CITY OF LITCHFIELD PARK

DESIGN REVIEW BOARD

DATE: October 3, 2019
TO: Chairperson Charnetsky and Design Review Board Members
FROM: Jason Sanks, Planning Consultant
SUBJECT: Applications for Review by the Design Review Board (DRB)

The proposed elevation for the addition appears as follows:

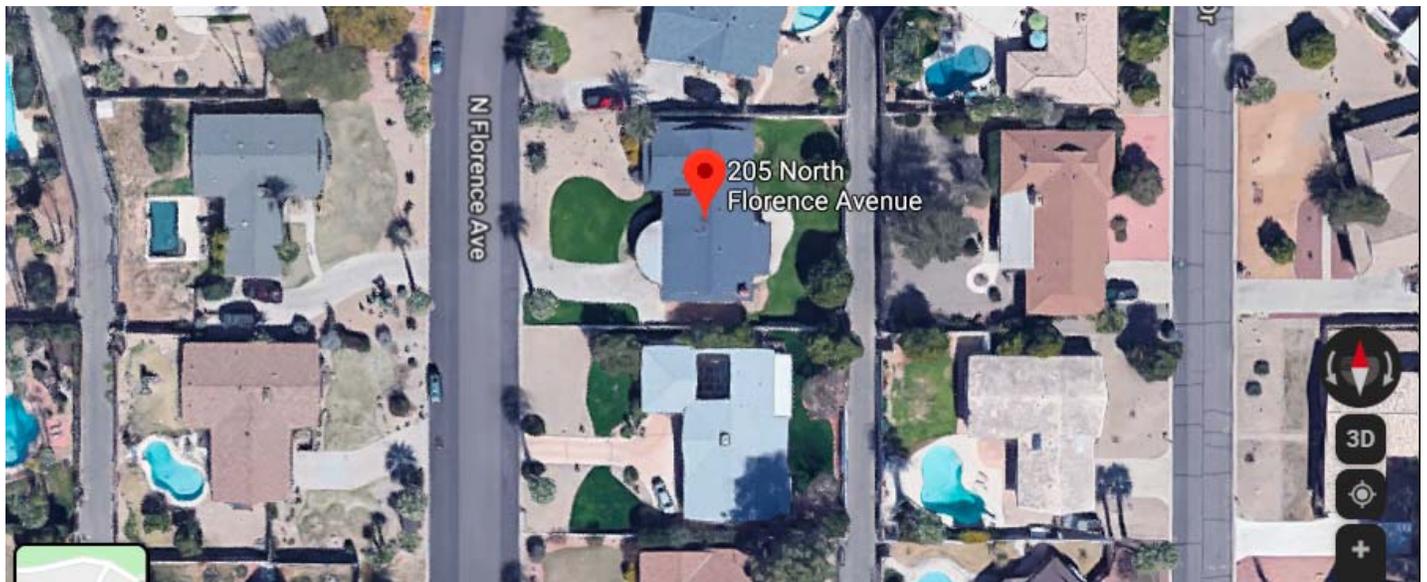
The proposed exterior elevations appear to integrate the rooflines of the garage addition with the existing residence. The garage doors feature horizontal paneling that complement other geometry on the front of the home. Based on the photo provided by the applicant, it appears that the circular carport is a unique attractive feature on the residence but perhaps not as useful as the homeowner desires. The full-size truck appears to not fully fit under cover. The 3-car garage will provide enclosed parking for the home and is a feature generally expected for homes in the area.

The site plan for the project indicates that there will be a significant driveway expansion to accommodate the width and access for the garage. The owner should consider a driveway taper so that the driveway access to the street is narrower and complements the streetscape like the current drive and other narrower drives found on neighboring drives as shown below:

- 1) The colors and materials of the addition will match those of the existing residence.
- 2) The driveway will be tapered down from 3-car widths to a 2-car width before reaching the street.

The proposed elevation for the rear addition appears as follows:

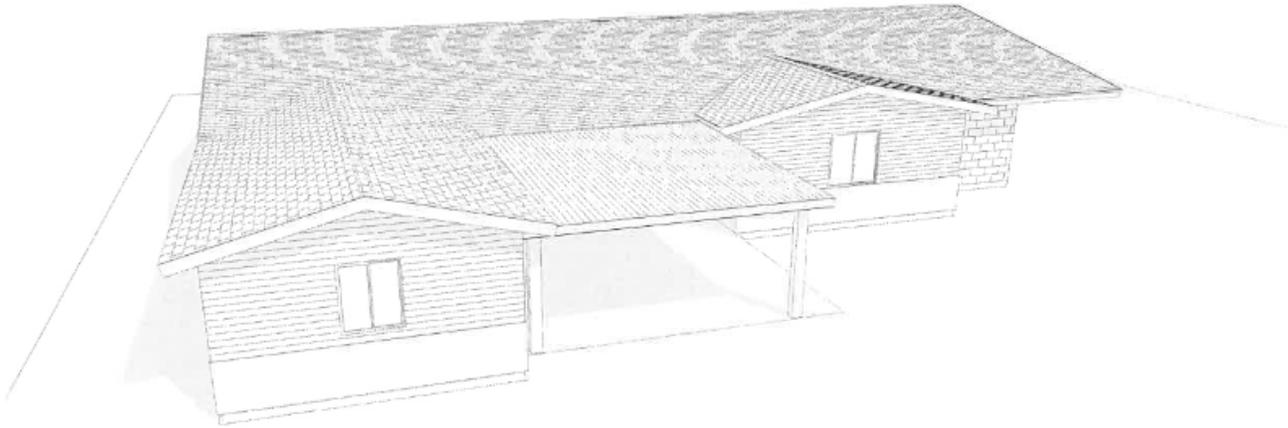
The proposed addition appears to match the existing residence in terms of roof lines and pitch. The black line elevations, however, do not appear to match the home's stucco finish from the street view. The black line elevations show what appears to be existing slump block with the proposed addition to be wood slat siding. The applicant will need to confirm what finishes are proposed and that they will match the home.

- 1) All colors, building materials, and finishes shall match those of the existing residence.
